# AMENDED

## CORRECTIVE ACTION PLAN

## Aspen Meadows Apartments

March 3, 2022  
Amended January 13, 2023

Photo AM5 – Measured height of 69 ½” to top of mailbox bank.

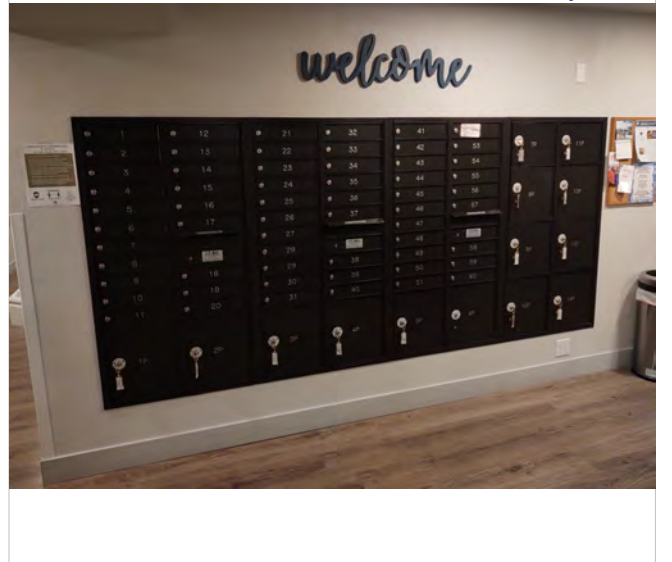
4.2.6	Mailboxes - Side Approach	The maximum high side reach allowed is 54" above the floor.	The height to the top of the mail boxes is 69 1/2"	AM #4 & AM #5	<b>Residents with disabilities can request the U.S. Postal Service to accommodate their disability by assigning them a mailbox on the bottom row.</b>	No cost	\$0						Completed	
<b>First Level Public Unisex Toilet Room</b>
